Well Name: POKER LAKE UNIT 28-21 BS MON POW	Well Location: T25S / R31E / SEC 28 / NENE /	County or Parish/State:
Well Number: 158H	Type of Well: CONVENTIONAL GAS WELL	Allottee or Tribe Name:
Lease Number: NMLC062140A	Unit or CA Name: POKER LAKE	Unit or CA Number: NMNM071016X
US Well Number: 3001548957	Well Status: Approved Application for Permit to Drill	Operator: XTO PERMIAN OPERATING LLC

Notice of Intent

Procedure Description: **Surface Location Move, Name Change, Spacing, Casing/Cement, Drilling Variance Changes XTO Permian Operating, LLC requests permission to make the following changes to the original APD: Change name fr/Poker Lake Unit 28-21 BS 158H to Poker Lake Unit 28-21 BS Mon 158H XTO Permian Operating, LLC. requests to make this a monitoring well to collect formation pressure responses in establishing greater understanding of parent/child relationships between wellbores. This data is beneficial for Poker Lake Unit to assist in an accelerated understanding of the number of wells and spacing configurations required to optimize Federal oil and gas mineral development throughout the unit. The monitoring well will either be converted to a producer or be plugged within 5-ye

13-3/8" x 9-5/8" x 5-1/2" 10M RSH-2 Wellhead
Assembly, With T-EBS-F Tubing Head

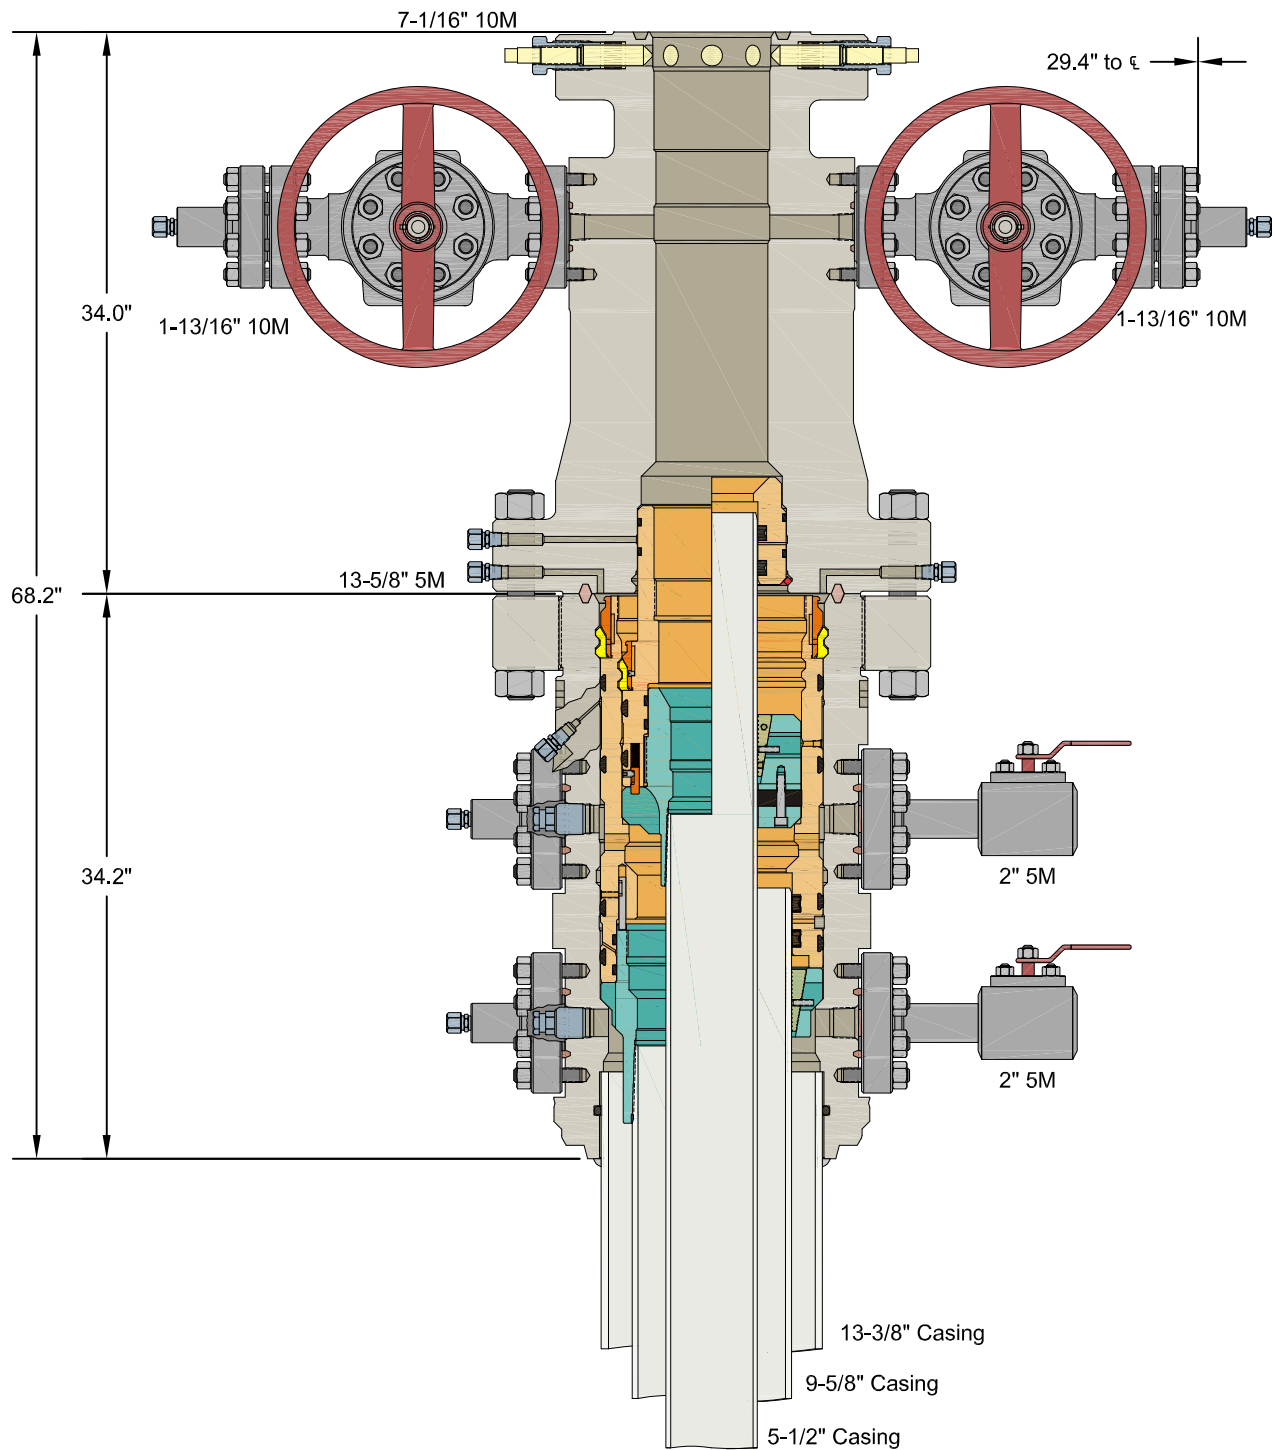
Permanent Wellhead – Multibowl System

A. Starting Head: 13-5/8" 10M top flange x 13-3/8" SOW bottom

B. Tubing Head: 13-5/8" 10M bottom flange x 7-1/16" 15M top flange

- Wellhead will be installed by manufacturer's representatives.
- Manufacturer will monitor welding process to ensure appropriate temperature of seal.

- Operator will test the 7-5/8" casing per BLM Onshore Order 2
- Wellhead Manufacturer representative will not be present for BOP test plug installation

1. Operator has proposed a multi-bowl wellhead assembly. This assembly will only be tested when installed on the surface casing. Minimum working pressure of the blowout preventer (BOP) and related equipment (BOPE) required for drilling below the surface casing shoe shall be **5000 (5M)** psi.

- a. Wellhead shall be installed by manufacturer's representatives, submit documentation with subsequent sundry.
 - b. If the welding is performed by a third party, the manufacturer's representative shall monitor the temperature to verify that it does not exceed the maximum temperature of the seal.

- c. Manufacturer representative shall install the test plug for the initial BOP test.
 - d. If the cement does not circulate and one inch operations would have been possible with a standard wellhead, the well head shall be cut off, cementing operations performed and another wellhead installed.
